SERVICE BULLETIN

PAGING MODULATOR CARDS CI-PM-3-00

BULLETIN NUMBER:	SB-0011
REVISION:	A
DATE:	NOV 2004

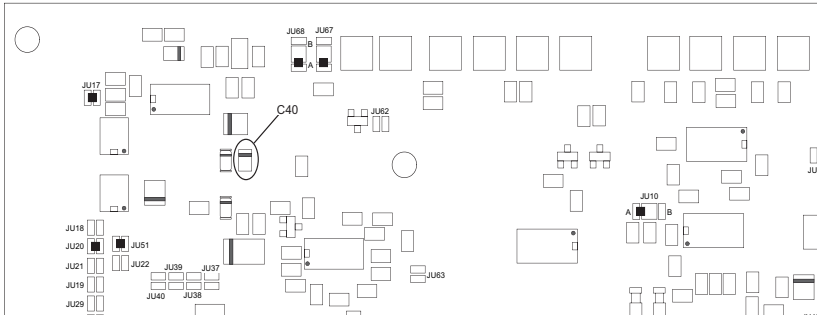
SYMPTOMS:		Component failure could result in module failure, blown subrack fuse, or system failure.	
------------------	---	--	---

CAUSE:	capacitor voltage under rated
---------------	-------------------------------

SOLUTION:	Remove C40 (a 1.0 μ f 16 V Tant) and/or replace with a 1.0 μ f 35 V Tantalum Capacitor

PARTS REQUIRED:	<p>If replacing C40:</p> <p>DE part number: 1055-5B105M35 CAP., SM, 1.0uF TANT., 20%,35V KEMET T491B105M035AS</p>
------------------------	---
